# **JAFNPP**

## **IMPROVED STANDARD TECHNICAL SPECIFICATIONS (ISTS) CONVERSION**

### **ITS: 5.5**

### **MARKUP OF NUREG-1433, REVISION 1 SPECIFICATION**

5.5.8

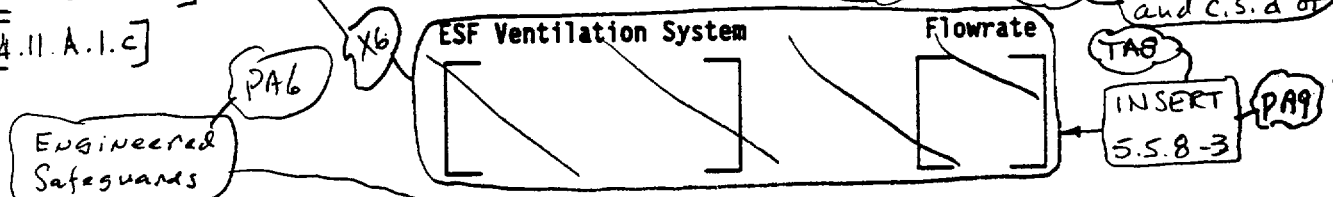
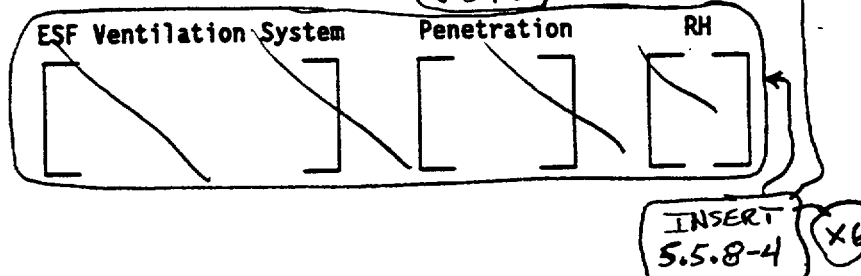
- b. Demonstrate for each of the ~~ESF~~ systems that an inplace test of the charcoal adsorber shows a penetration and system bypass ~~< 0.05%~~ when tested in accordance with ~~Regulatory~~ 1980 Guide 1.52, Revision 2, and ASME N510-1989 at the system flowrate specified below ~~(+ 10%)~~.

- c. Demonstrate for each of the ~~ESF~~ systems that a laboratory test of a sample of the charcoal adsorber, when obtained as described in ~~Regulatory~~ Guide 1.52, Revision 2, shows the methyl iodide penetration less than the value specified below when tested in accordance with ~~ASTM D3803-1989~~ at a temperature of ~~≤ (30°C)~~ and ~~greater than or equal to~~ the relative humidity specified below. ~~(86°F)~~

- CLB7 ITS 5.5.8.c has been revised to reflect the current JAFNPP requirement in CTS 4.7.B.1.c and CTS 4.11.A.2 that charcoal absorber samples are obtained as described in Section C.6.b of Regulatory Guide 1.52, Revision 2 and that the minimum temperature for analysis is 30°C or 86°F.

- X5 Not Used.
- X6 The bracketed values for penetration and system bypass have been incorporated into ITS 5.5.8 consistent with the current requirements in CTS 4.7.B.1 and 4.11.A.1 as modified by M2.
